Access Compliance Report

Public Rights-of-Way

(Curb Ramps)

Intersection ID: 50707	Main Street: CONGREGATION_DR	Cross Street: BROTHERLY_LN	Location: NE
ADA ID: 76CF3E883949	Ramp Type: PerpDiag	Initial Pass/Fail: Fail	Overall Compliance: No
Codes/Mitigation Info/Possible Solution		Field Measurements/Component Compliance

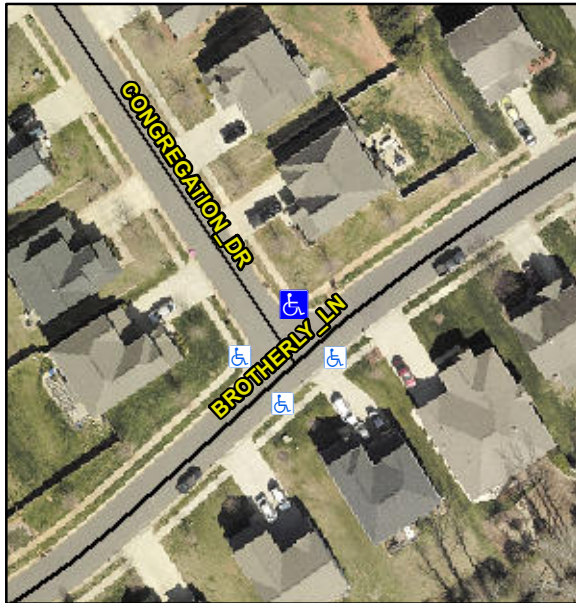
Not Found, R304.5.1, R304.2.2, R304.5.3

Compliance	Description	Data	Compliance	Description	Data
N/A	Ramp Length (in)	49.5	No	Ramp Slope (%)	10.6
No	Ramp Width (in)	47.5	No	Ramp XSlope (%)	5.8
N/A	Flare Type LT	N/A	N/A	Flare Type RT	N/A
N/A	Flare Slope LT (%)	N/A	N/A	Flare Slope RT (%)	N/A
N/A	Flare Traversable LT?	N/A	N/A	Flare Traversable RT?	N/A
N/A	Landing Length (in)	N/A	N/A	DWS Provided?	N/A
N/A	Landing Width (in)	N/A	N/A	DWS Contrast?	N/A
N/A	Landing Slope (%)	N/A	N/A	DWS Length (in)	N/A
N/A	Landing X Slope (%)	N/A	N/A	DWS Full Width?	N/A
N/A	Landing Curb? (Y/N)	N/A	N/A	DWS Offset (in)	N/A
N/A	Shared Landing?	N/A			
N/A	Gutter Ponding?	N/A	N/A	Gutter Slope (%)	N/A
N/A	Gutter Lip Ht (in)	N/A	N/A	Gutter X Slope (%)	N/A
N/A	Painted X Walk1?	No	N/A	Painted X Walk2?	No
	X Walk 1 Direction	To SW		X Walk 2 Direction	To SE
N/A	X Walk 1 Width (in)	N/A	N/A	X Walk 2 Width (in)	N/A
	X Walk 1 Slope (%)	3.6		X Walk 2 Slope (%)	0.7
	X Walk 1 X Slope (%)	3.0		X Walk 2 X Slope (%)	2.9

Remove & Replace Curb Ramp With Two New Directional Ramps or Equivalent.
